**Bureau of Project Delivery
Bridge Design and Technology Division**

No. 049
May 4, 2018

**BRADD v3.2.4.0: Pile Cap Depth Too Large for One
Integral Abutment – Patch Available**

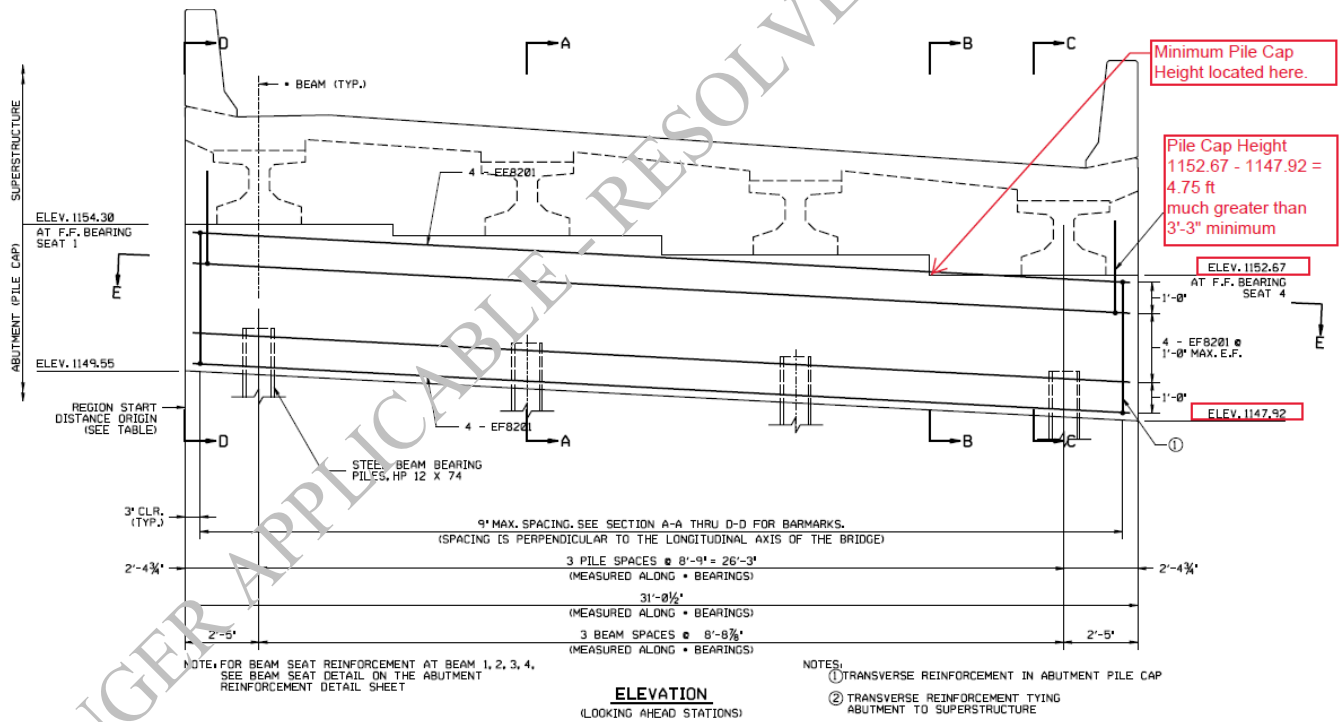
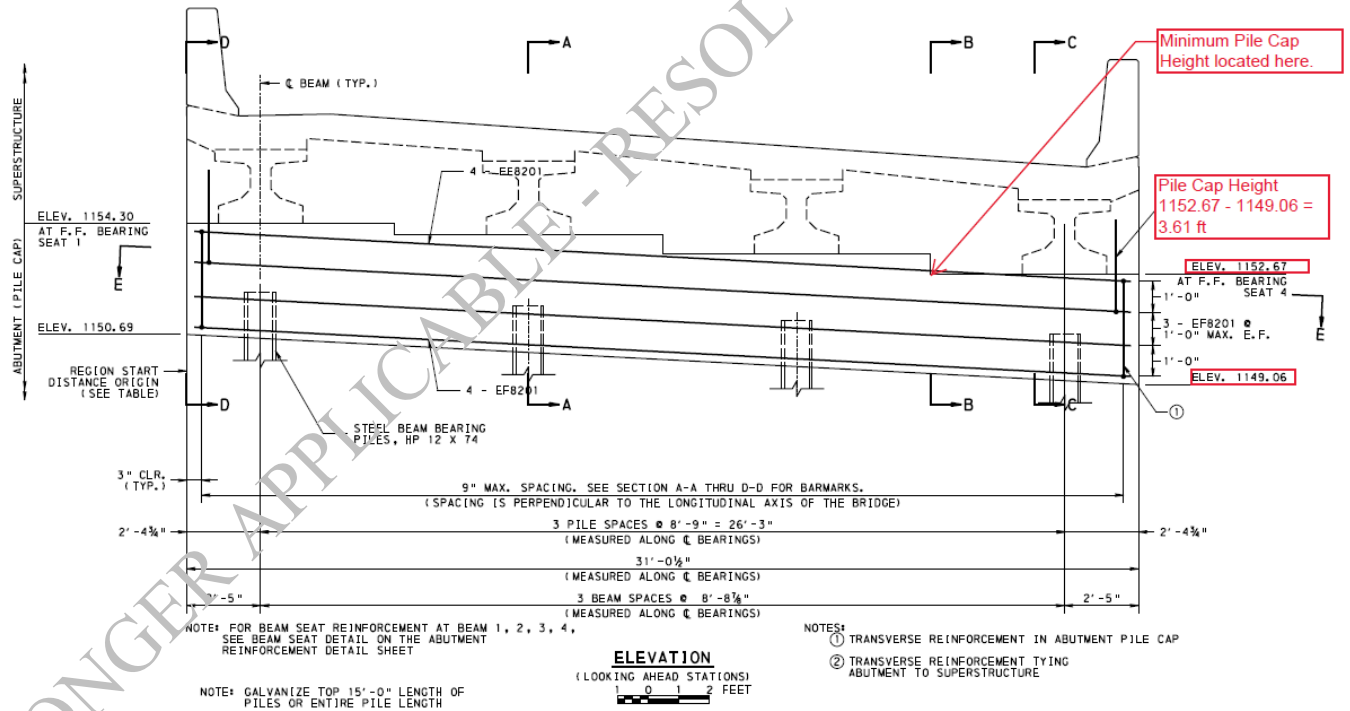
For bridges that have integral abutments and a full super elevation cross-section above the integral abutment, the height of the pile cap that is calculated is too large (the minimum pile cap height exceeds 3'-3"). This problem only occurs when the bottom of the pile cap is sloped downwards (left-to-right, facing the abutment) and usually only occurs at one of the integral abutments.

A fix for this problem is available in BRADD patch version 3.2.4.2 which can be downloaded for free as a patch from the BRADD website.

The following shows the integral abutment elevation that is created after the patch has been installed.
